Detailed Site Plan Chick-Fil-A, Capital Plaza

DSP-15020-05

STAFF REPORT

SUBJECT: Detailed Site Plan DSP-15020-05 Chick-Fil-A, Capital Plaza

Figure 3: Building Signs

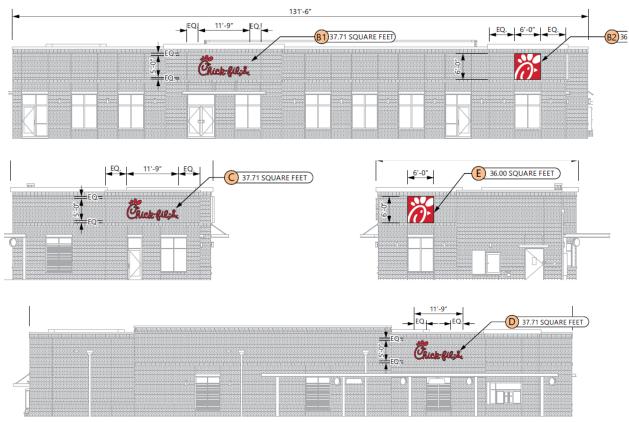
Signage—The application proposes five internally-illuminated, building-mounted signs that include the corporate logo and the name of the restaurant. The signs are proposed on each façade with two of the five signs proposed on the east side of the building near the main access into the restaurant, and one sign on the north, south, and west side of the building and have been found acceptable.

Page 181– E. Signage: Signs should be externally lit, and light should be directed to illuminate the sign face only and to prevent any light spillover. Lighting sources should be concealed by landscaping.

The applicant is proposing to install internally lit signs on the north, south, and east facades of the proposed building, which is not allowed by the D-D-O. Therefore, a modification to this standard is required. The majority of the signs face the internal parking lot, and do not face the public right-of-way of MD 450. Therefore, due to the location of the majority of these building-mounted signs it has been found that their internal illumination would not substantially impair the sector plan vision for the corridor and staff recommends approval of this modification.

- Standard V.E.1.h. (page 181)
 Signage—To allow an internally lit sign on the North and East elevations on the proposed building.
 - 5. Standard VI.D.2.a. (page 182)
 Landscape Standards-Parking lot requirements—To provide three to four-foot shrubs in lieu of providing a wall, between the parking lot and the right-of-way.

Figure 5: Parking Space Location

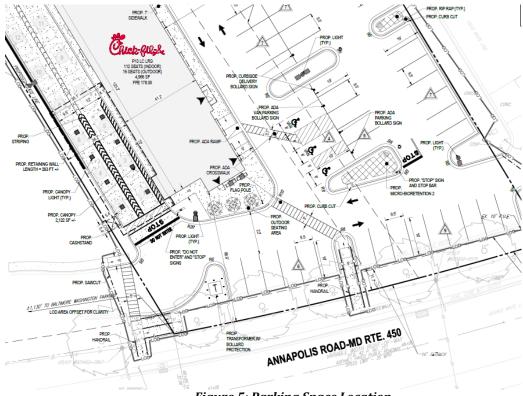
Page 165– Parking and Access Management: No parking shall be located in the front yard or corner side yard.

Parking is proposed in the front yard adjacent to MD 450, and while the applicant did not specifically request a modification from this design standard, staff believes this modification is needed. Staff believes that the use will generate the need for additional 15 parking spaces that is needed to adequately serve the demand of vehicles accessing the site. It is important to note these spaces will be adequately

screened from the public right of way by proposed landscaping and elevation change. In addition, it is noted that these spaces do not increase the building setback and the building location is consistent with the adjoining properties. For these reasons, staff supports the modification and recommends approval.

- Standard IV. C.1. (page 166)
 Parking and access management—To allow the applicant to include parking located in the front yard if the property.
 - Standard IV. C.2. (page 166)
 Parking and access management—To allow the applicant to exceed the maximum parking permitted by the 2010 *Approved Central Annapolis Road Sector Plan and Sectional Map Amendment* by providing 1,944 parking spaces.
